**New Albany Architectural Review Board Meeting Agenda**  
Monday, March 09, 2026, 7:00 p.m.

**FDP-88-2025 Healthy New Albany Food Pantry Final Development Plan**

HEALTHY NEW ALBANY FOOD PANTRY  
FINAL DEVELOPMENT PLAN  
CERTIFICATE OF APPROPRIATENESS

Re: Healthy NA Food Pantry  
Final Development Plan

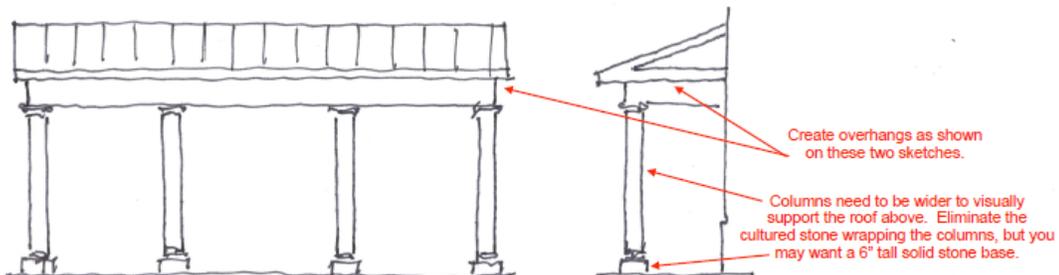
- The two-story gable at the main entry appears inconsistent with the overall front façade. The City Architect recommends removing the gable and redistributing the windows to achieve a more balanced and cohesive design. If the gable is retained, a centered second-story window will be required, as illustrated below.

- Provide a taller roof pitch on cupola.

- Create overhangs as shown on the sketch below
- Columns should be wider to visually support the roof above. Eliminate cultured stone wrapping the columns and use a 6' tall solid stone base.
- Align neck of columns.

### 1 SITE PLAN

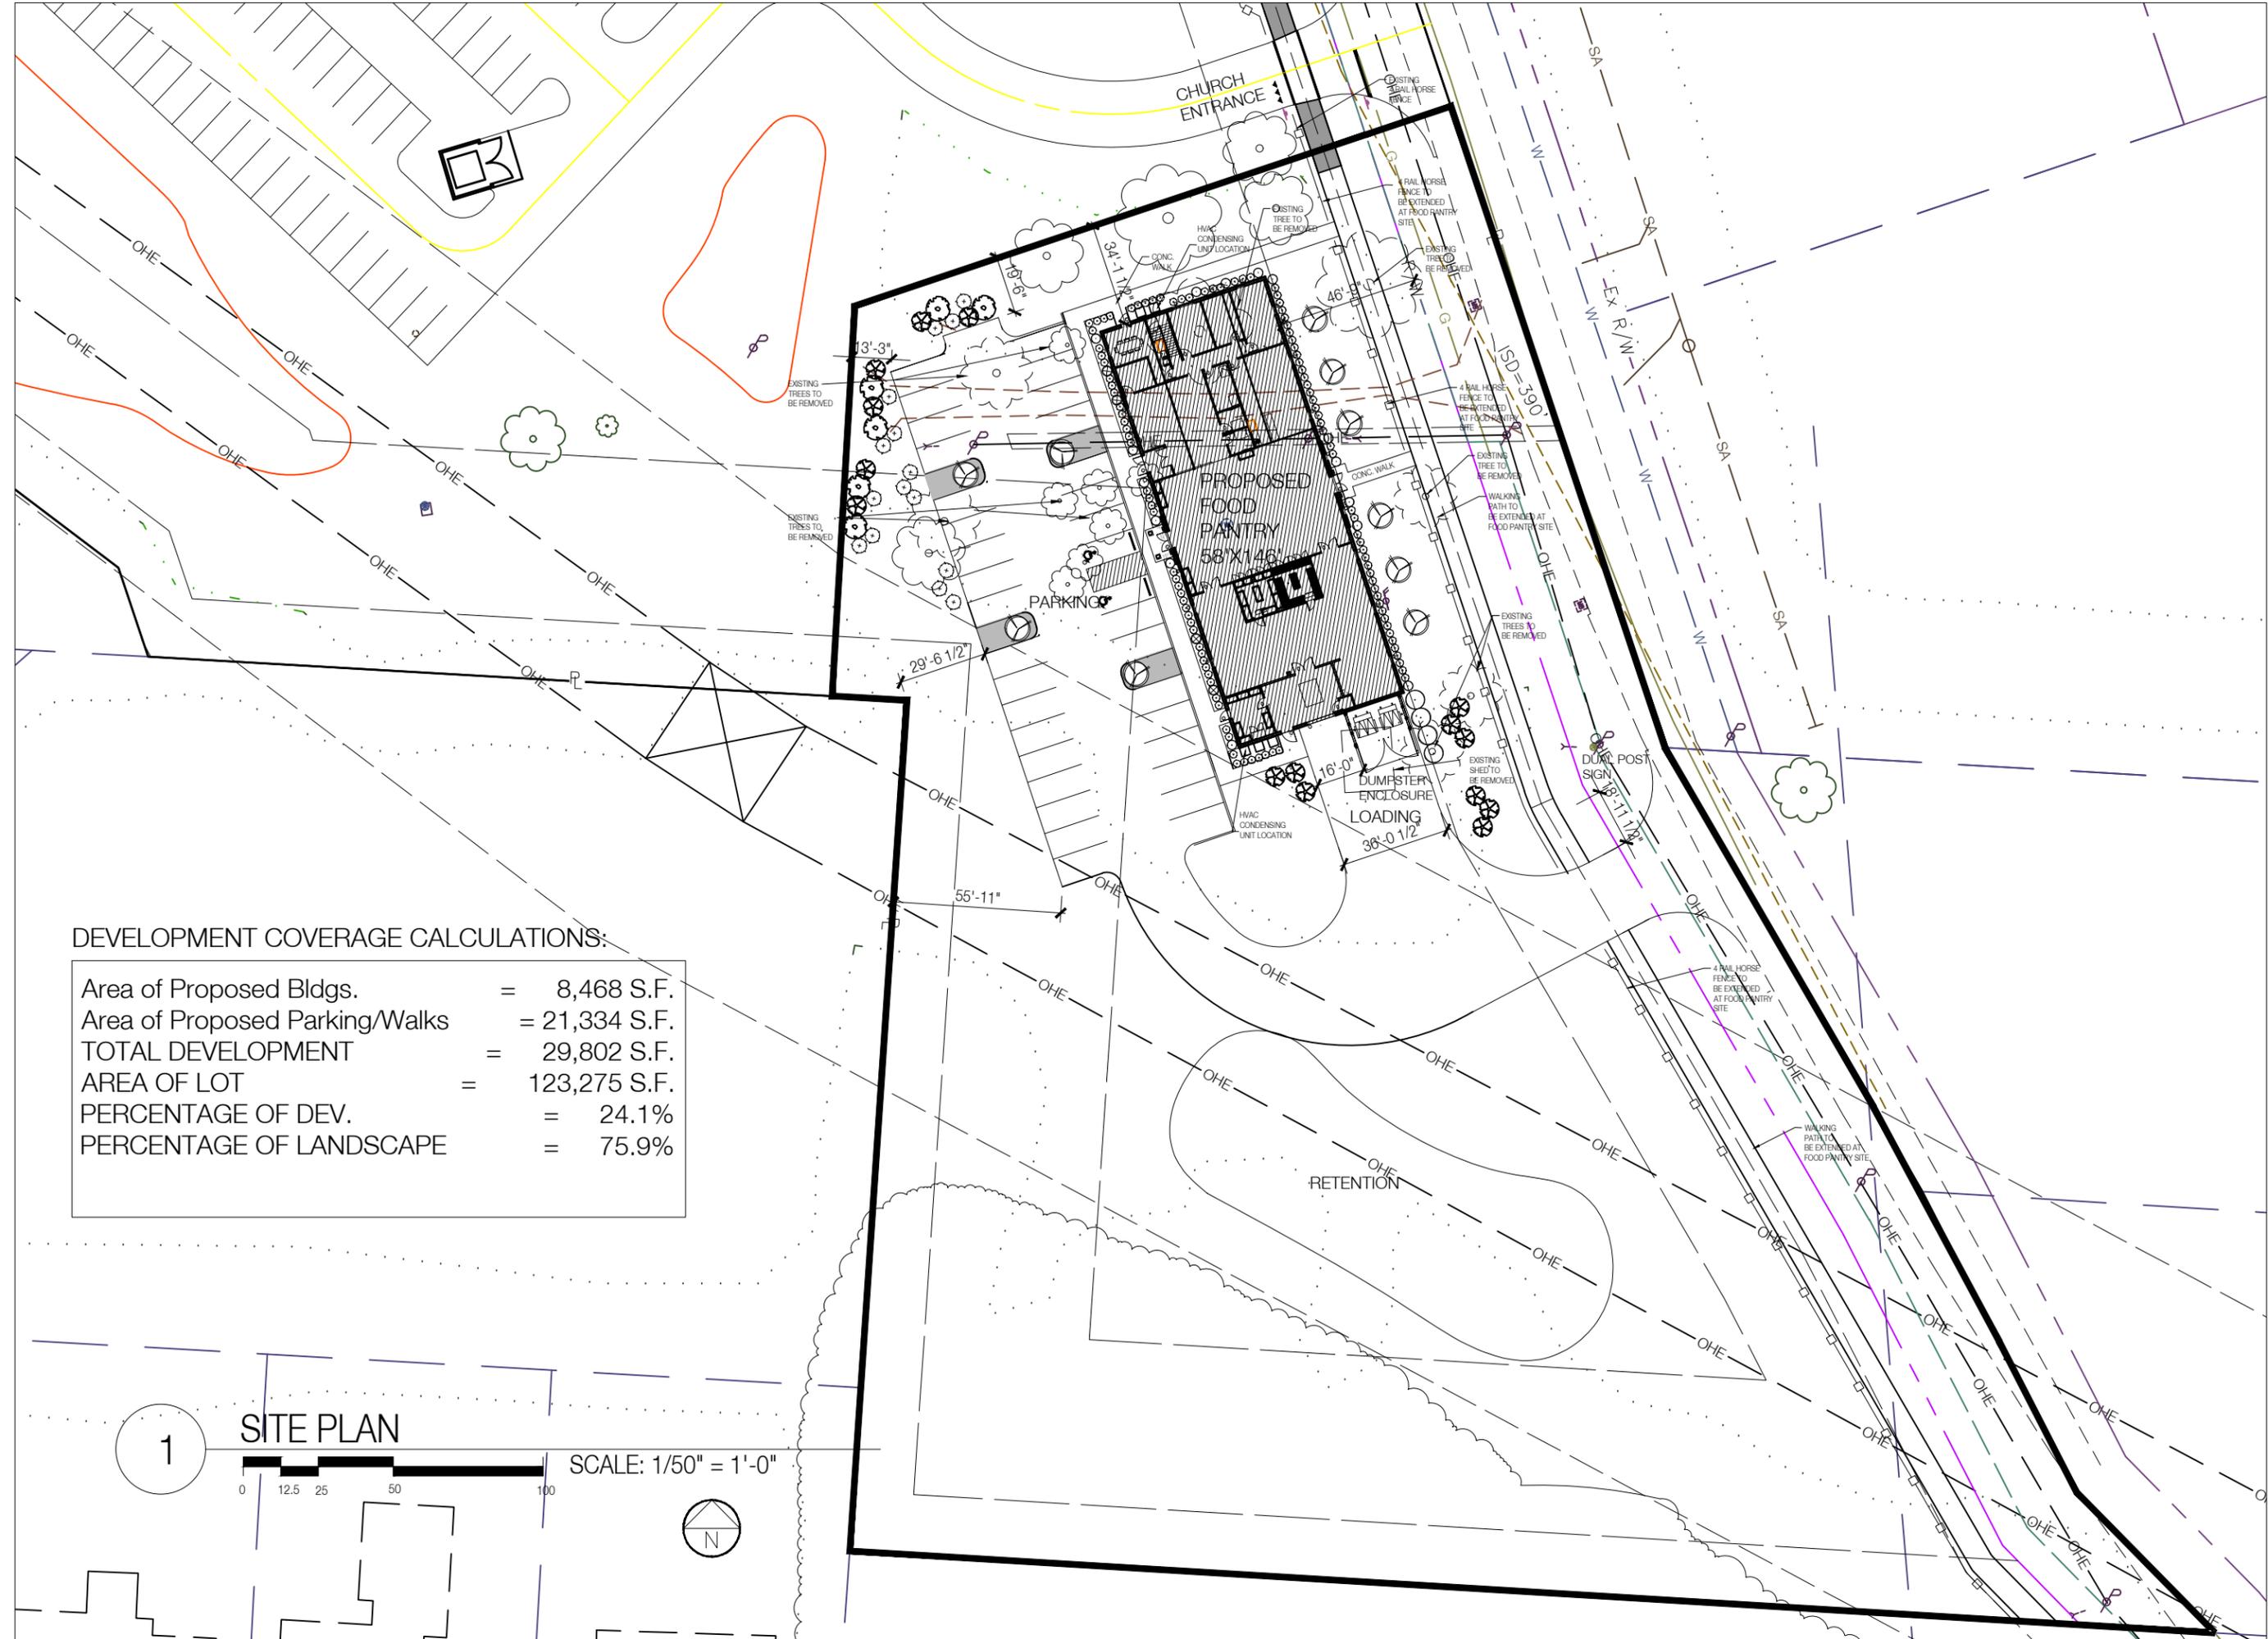
- Reduce the width and overall square footage of the paved drive apron in the area outlined in the memo or provide additional turning radius studies in support of the current alignment (including necessary vehicular movement specific to the loading and trash receptacle area).

1. Reduce the width and overall square footage of the paved drive apron in the area outlined below, or provide additional turning radius studies in support of the current alignment (including necessary vehicular movement specific to the loading and trash receptacle area). See below.

1 LANDSCAPE PLAN  
 SCALE: 1/30" = 1'-0"

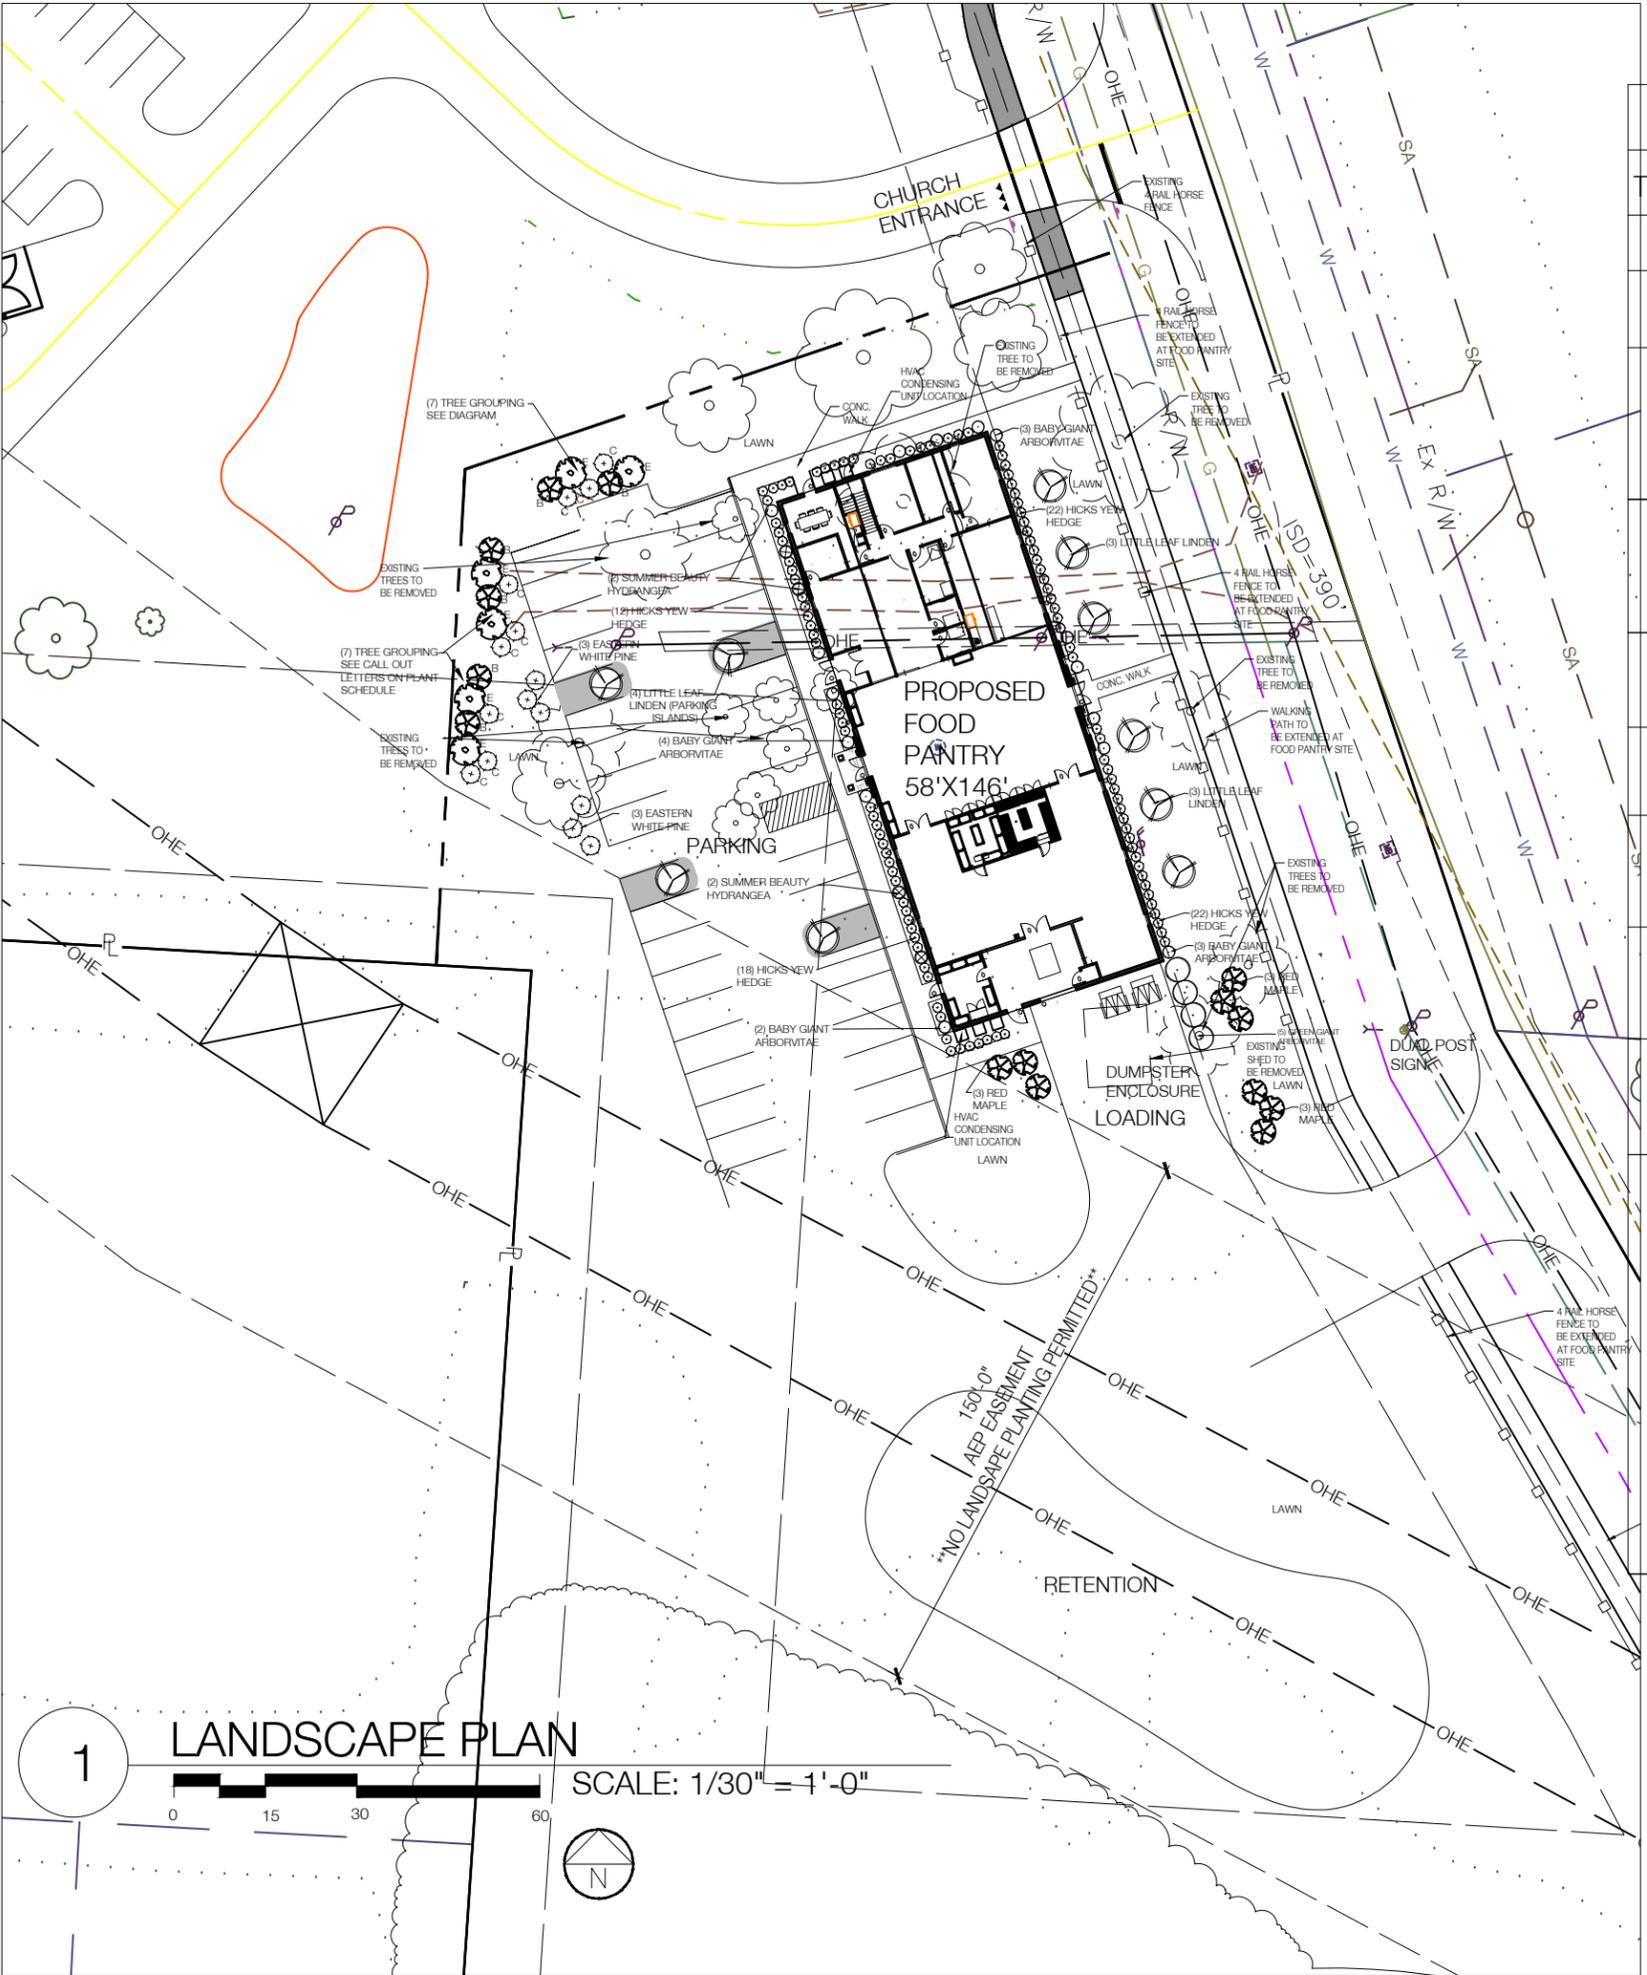
- Revise the proposed landscape plan to remove the Green Giant Arborvitae at the edge of the parking lot. Replace screening material with deciduous shade trees.

- Adjust the proposed retention basin location to avoid the removal of the existing tree stand as outlined on sheet L102 of the submitted materials.
- Additional landscaping is proposed to be installed for the development on James River Park to help facilitate additional screening.

2. Revise the proposed landscape plan to remove the use of Green Giant Arborvitae (*Thuja plicata x standishii* 'Green Giant') at the edge of the parking lot. Replace screening material with deciduous shade trees. See below.
3. Recommend the adjustment of the proposed retention basin location to avoid the removal of the existing tree stand as outlined on sheet L102 of the submitted materials. See below.
